MEMORANDUM

DATE: January 10, 2024

SUBJECT: Engineering Geologic Review of Timber Harvest Plan 1-23-00099 SON

Date: 1/2024	Regional Landslide Map To Accompany Engineering Geologic Review of THP 1-23-00099 SON	Figure: 4
Scale: 1" = 2000'

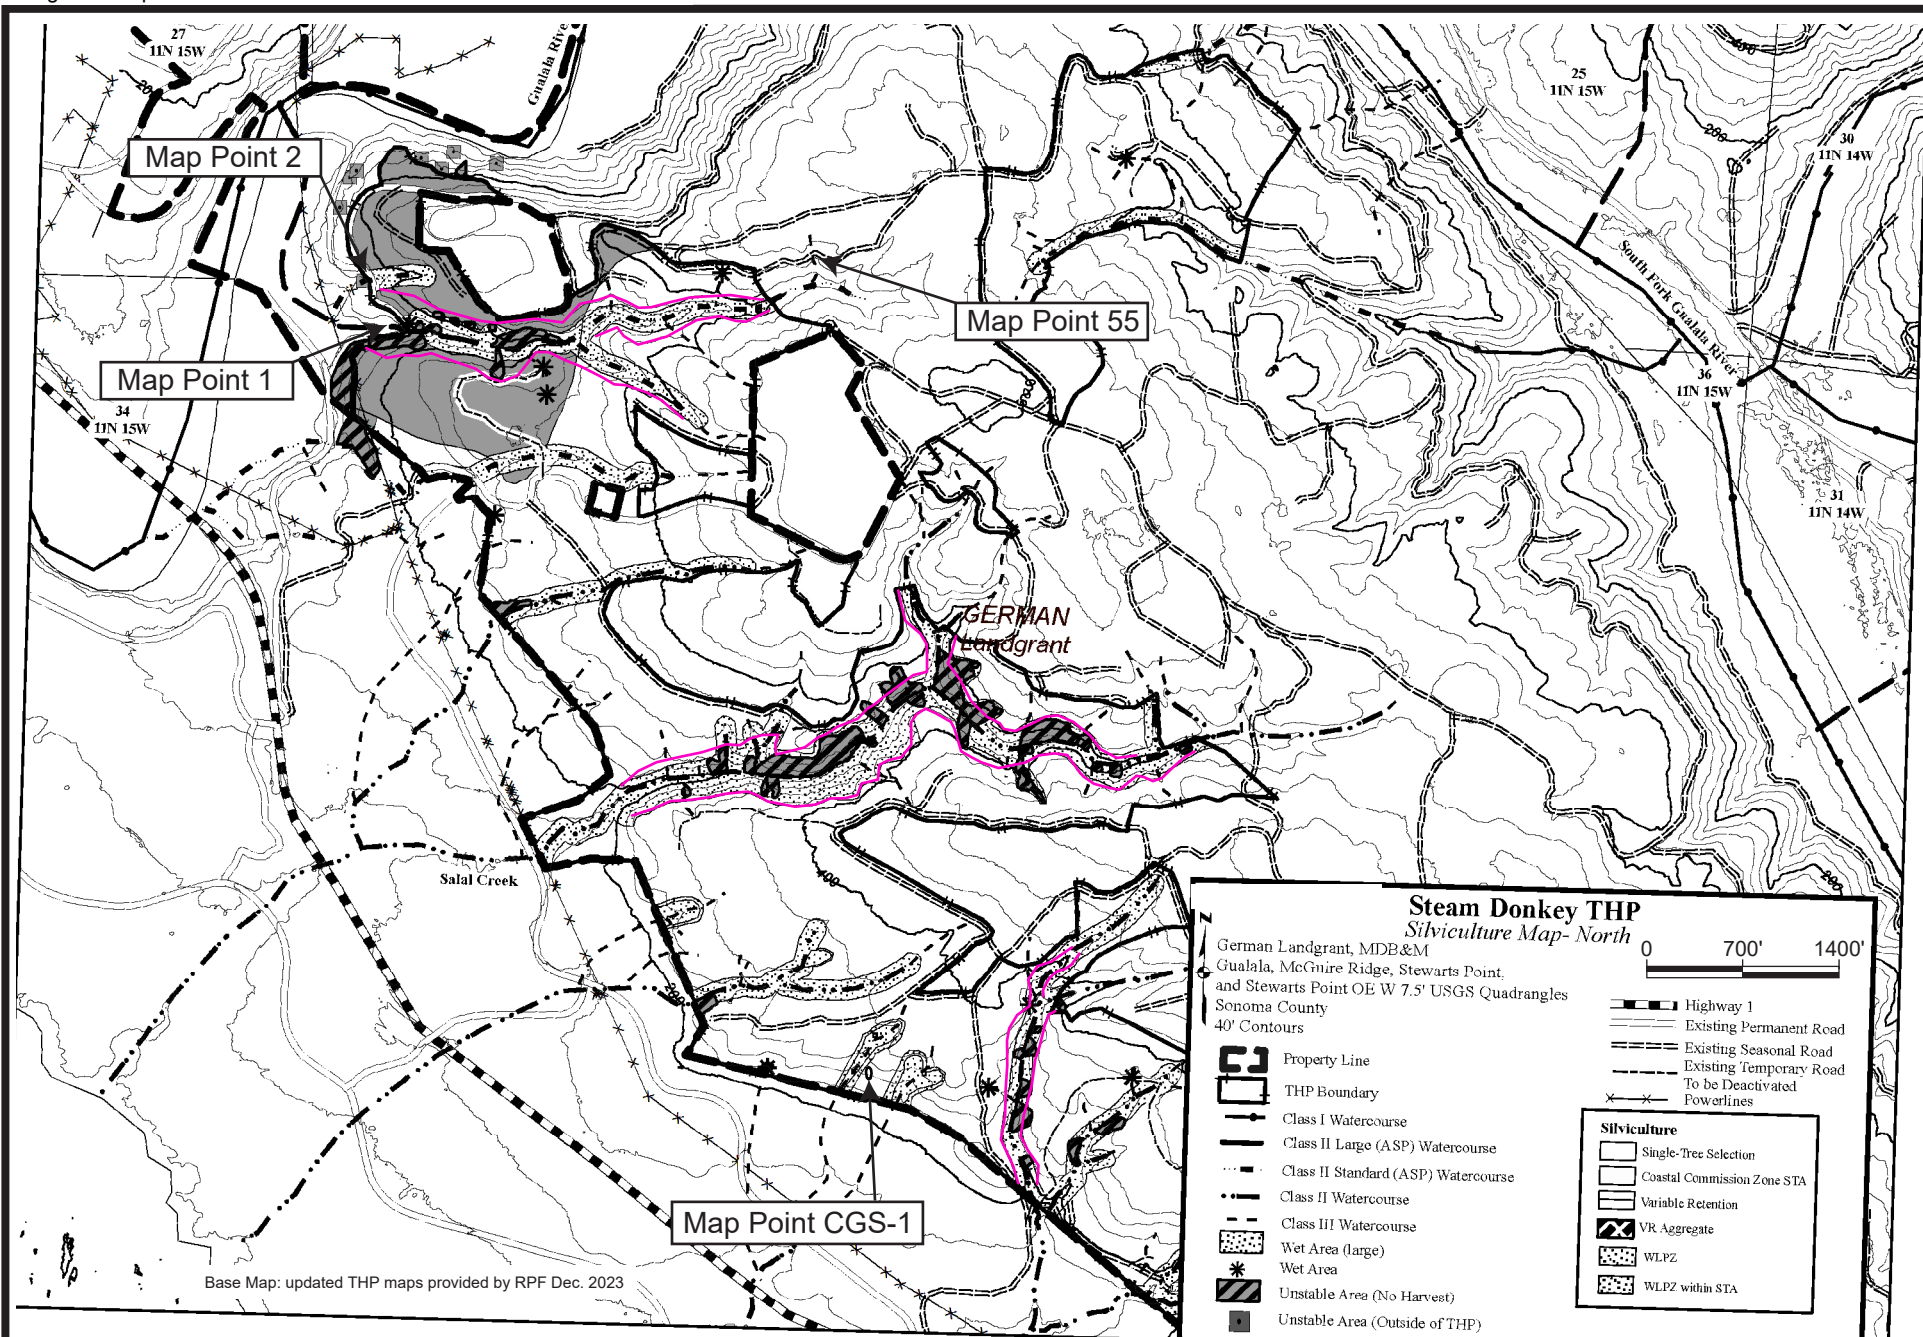
3). Deep Seated Landslides. Published mapping shows apparent deep-seated landslides in the vicinity of the THP area located along northeast-facing slopes that drain to the South Fork Gualala River. Blake and others (2002; Figure 1) and Huffman and Armstrong (1980; Figure 4) identify a similar very large landslide complex in this area, while Fuller and others (2002; Figure 2) interpret smaller dormant deep-seated landslides along these slopes. Review of LiDAR imagery reveals subtle, bowl shaped headscarp slopes and benched and hummocky topography across these slopes where Blake and others (2002; Figure 1) and Huffman and Armstrong (1980; Figure 4) identify the very large landslide complex. LiDAR imagery generally shows more defined landslide features with somewhat more youthful morphology nested within this large landslide complex at the locations where Fuller and others (2002; Figure 2) identify dormant deep-seated landslides. During our review, we observed that these slopes are generally forested with straight standing advanced-growth conifers and old-growth stumps. Evidence of recent large-scale, deep-seated earth movement (for example ground cracks, bare scarps, offset road prisms) was not observed during the PHI. Based on our observations, the large deep-seated landslide complex and nested blocks appear to correspond to the "dormant-mature" to "dormant-old" morphological age classification of Keaton and DeGraff (1996).

Site Map
To Accompany
Engineering Geologic Review of
THP 1-23-00099 SON

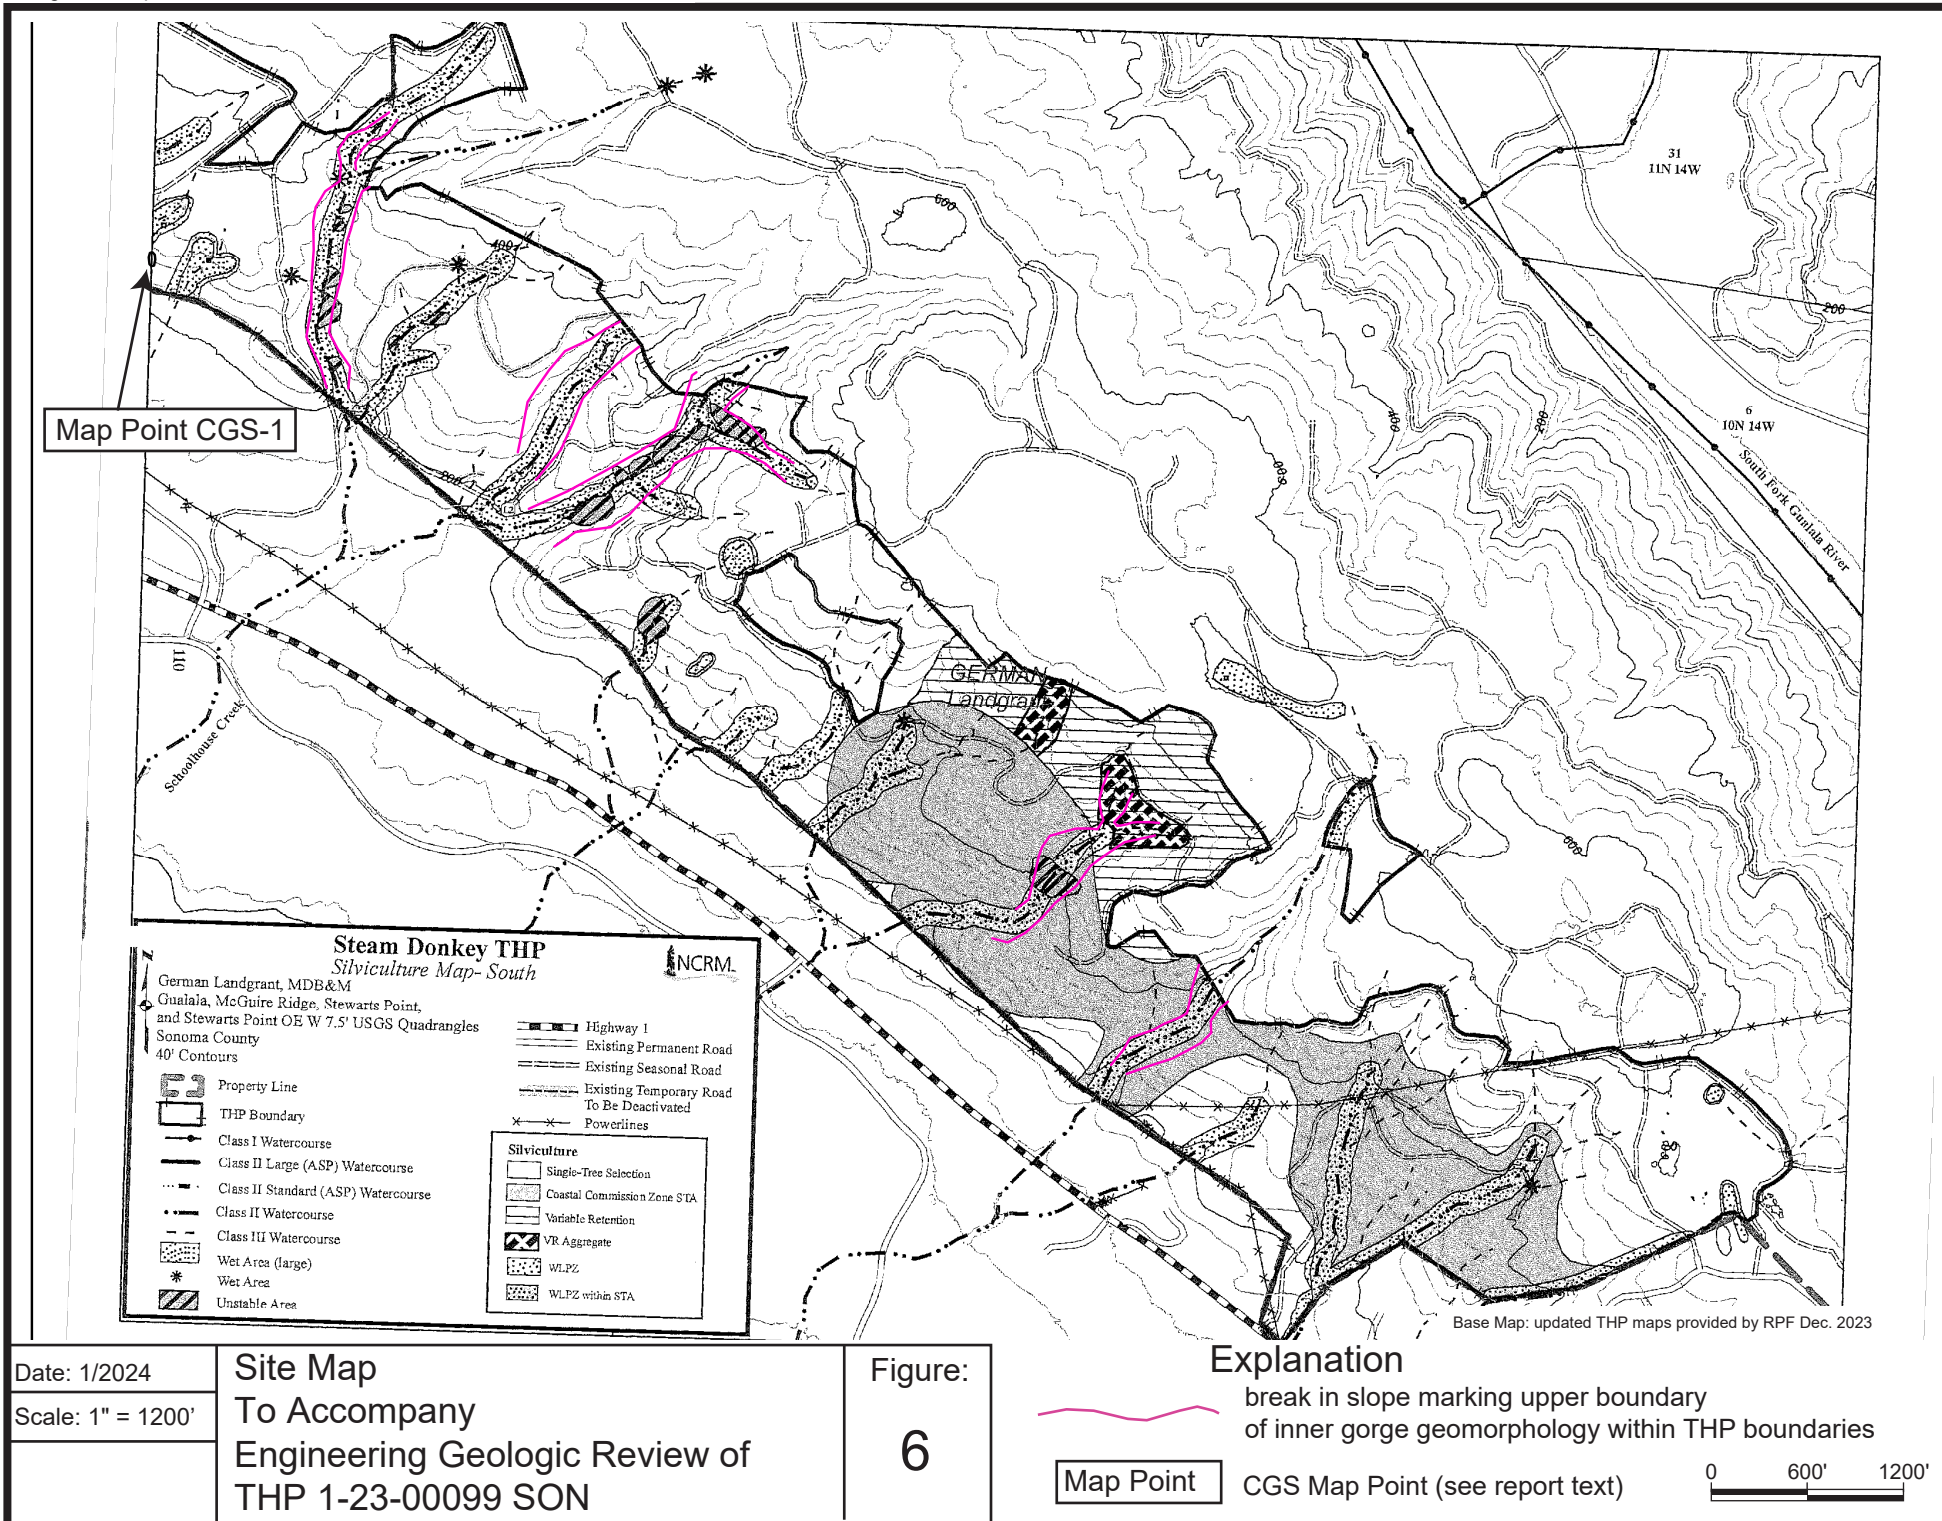
along these steep slopes, we also frequently noted the presence of vegetated bowl-shaped head scarps at or near the break in slope and spoon-/teardrop-shaped depressions/hollows extending downslope that appear to be indicative of former debris slide activity. These observations are consistent with the conditions for inner gorge formation described by Kelsey (1988) and the definition of inner gorge geomorphology from CGS Note 50 (CGS, 2013) and the Forest Practice Rules. Additionally, our review of the unpublished data discussed above (General Observation #1) revealed several instances where the GRI landslide database (GRI, 2004) records landslides in these areas with the noted "slope type" as inner gorge. Based on these observations, we conclude that the noted drainages have morphology consistent with inner gorge geomorphology. The interpreted break in slope in the areas of inner gorge geomorphology is shown on Figures 5 and 6.

THP. RPF response dated September 6, 2023 (Return No. 2 Responses) indicated that these past THP's were reviewed with respect to previously mapped unstable areas; however, during the first day of the PHI we field checked several of these locations and confirmed the presence of unstable areas that were not shown on the THP Operations Maps. After the first day of the PHI, the RPF performed additional review and field work, and submitted updated THP maps to the review team on December 14, 2023. The updated THP maps include additional unstable areas at locations where unstable areas are mapped in previous THP's and include revised mapping of some of the unstable areas shown on the original THP maps (Figures 5 and 6).

Over the course of the two-day PHI, we observed a representative sampling of the unstable areas shown on the revised THP maps (Figures 5 and 6), which generally consisted of suspended to dormant-historic debris slides, slumps, and skid trail failures that are nearly all located along steep slopes adjacent to watercourses within the THP area (some of which have inner gorge geomorphology; see General Observation #2). Item 38 (page 101) of the THP describes that all mapped unstable areas within the THP area are no-harvest equipment exclusion zones that are incorporated into the WLPZ areas. However, when submitting the updated THP maps to the review team the RPF clarified that Item 38 will need to be revised as some unstable areas extend outside of the WLPZ and are flagged with Do Not Cut flagging. Based on our observations, the updated THP maps (Figures 5 and 6) accurately depict the location of unstable areas, and the proposed avoidance and retention of canopy and root function on these mapped unstable areas appears adequate to minimize the potential for adverse impacts to slope stability of the unstable areas. One additional unstable area was observed during the PHI and is discussed under Specific Observations (Map Point CGS-1).

- 3). None
- 4). Prior to second review, Section II of the THP shall be revised to include the updated mapping of unstable areas as shown on THP maps that were provided to the review team prior on December 14, 2023 (Figures 5 and 6). Additionally, Item 38 shall be revised to discuss that some unstable areas extend outside of the WLPZ and are flagged with Do Not Cut flagging. Additionally, the RPF shall verify that all mapped unstable areas are flagged in accordance with Item 38 and that no trees are marked for harvest on mapped unstable areas prior to operations.

Site Map
To Accompany
Engineering Geologic Review of
THP 1-23-00099 SON

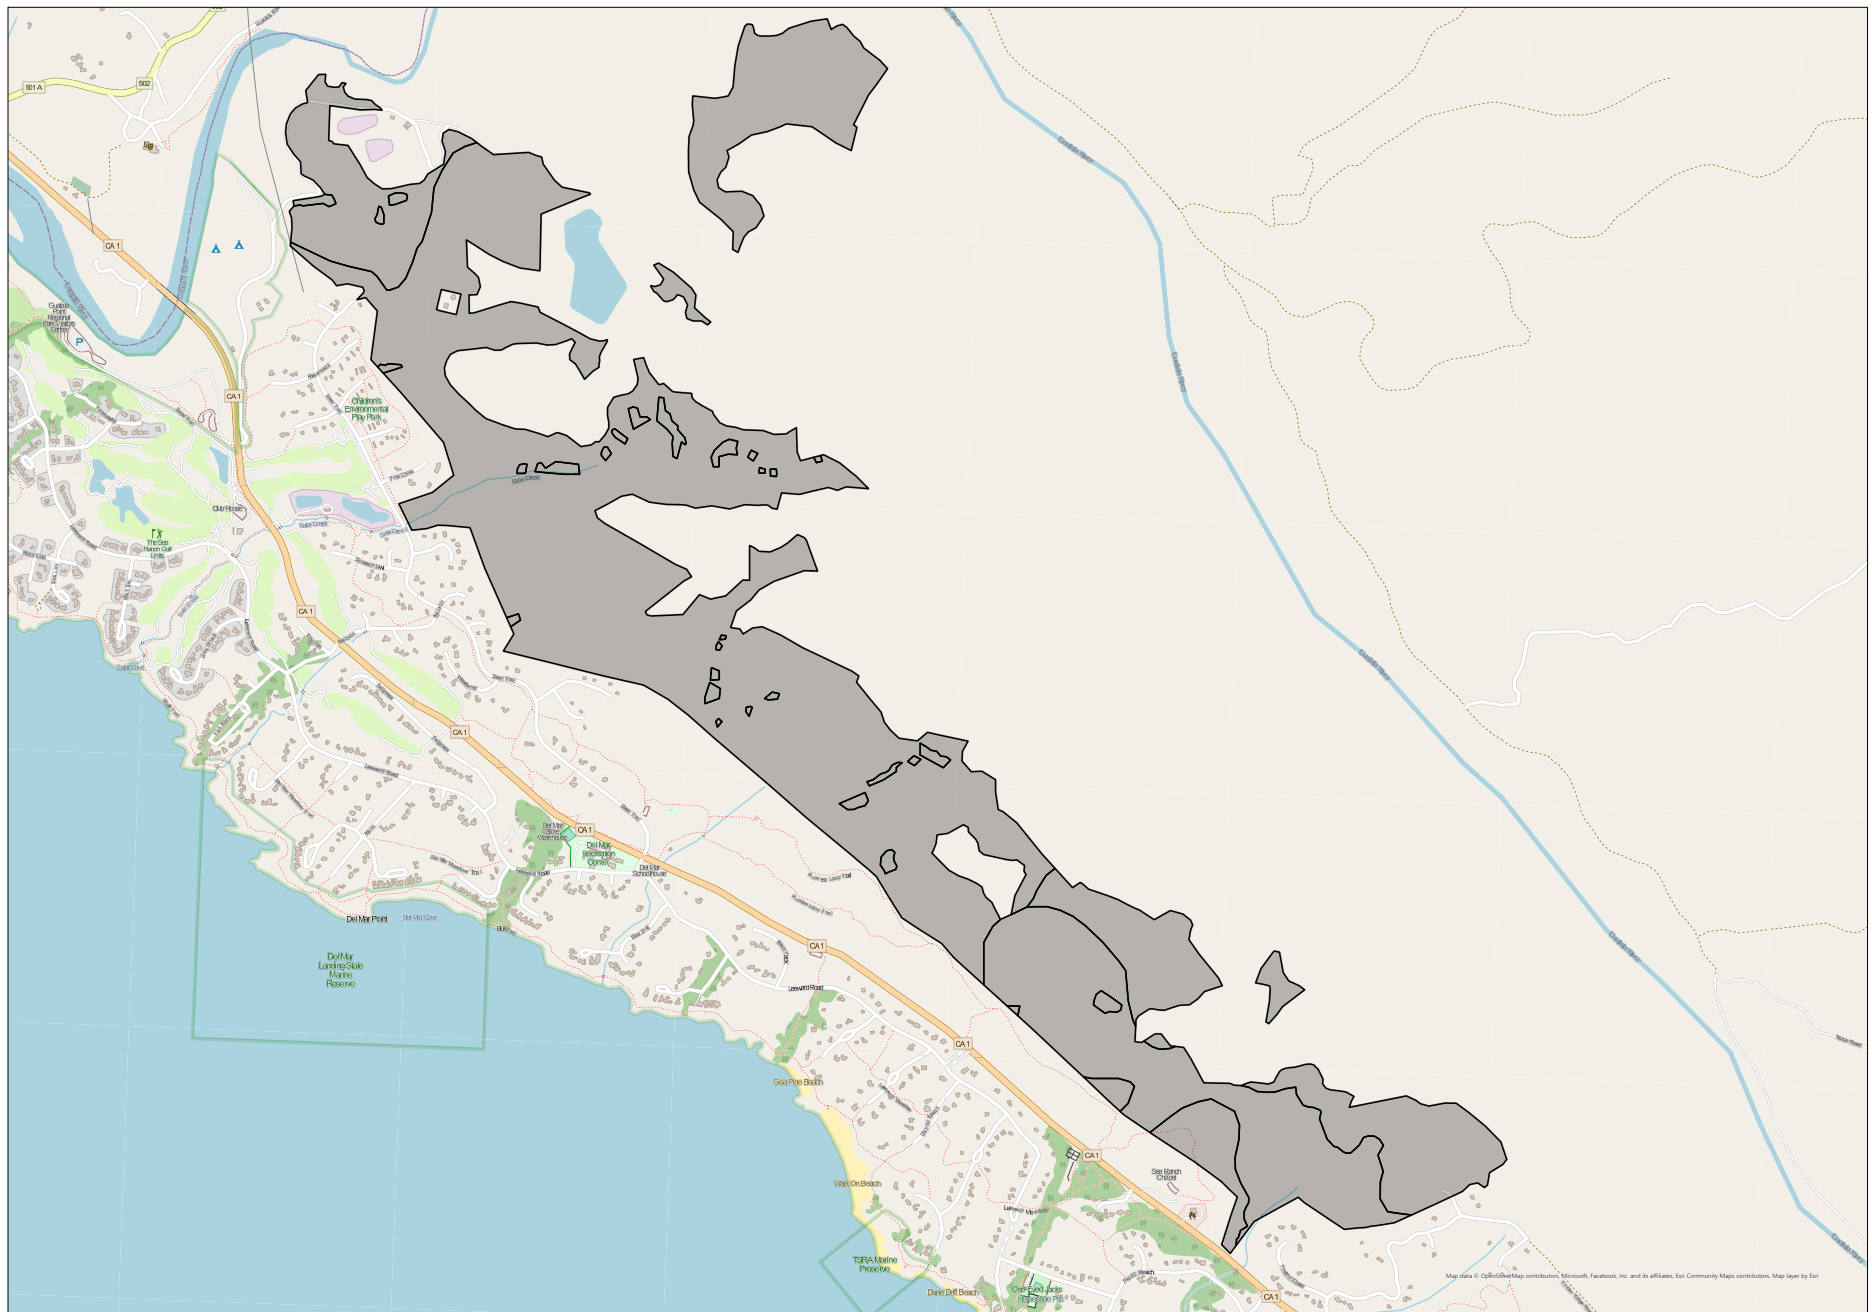
5). Public Safety. During our review of the THP, we noted that there are numerous residential structures/developments (for example Sea Ranch) and public roads and highways (for example Deer Trail road, State Route 1) downslope of the proposed THP area. We noted that the residential structures/developments are not shown on the THP maps (Figure 7). During the PHI, we discussed that these structures should be disclosed in the THP to provide complete information to the review team so that the review team can assess the proposed timber harvesting operations with respect to potential impacts to the downslope structures.

During our review, we evaluated the potential for operational impacts to slope stability that could impact these structures and developments, as well as the public roads and highways. Neither the THP, nor the published and unpublished mapping discussed under General Observation #1 identifies landslides/unstable areas along the slopes that descend toward the residential structures and development or the public roads and highways. During the PHI, we traversed portions of these slopes and observed that they are typically 30 to 45 percent gradients, with locally steep slopes and bedrock outcrops that exceed 50 percent gradients. Except for a small dormant-historic to dormant-young unstable area that was observed during the PHI (see Specific Observations below), we did not observed evidence of historic instability along these slopes. The observed unstable area was flagged for avoidance during the PHI and as such no harvesting operations are proposed on this feature (See Specific Observations below, Map Point CGS-1, for additional discussion). Based on our observations, the proposed operations, as augmented with the recommendations in this THP, appear unlikely to

5). Prior to second review, the THP maps shall be updated to disclose the location of residential structures and developments that are located downslope of the THP.
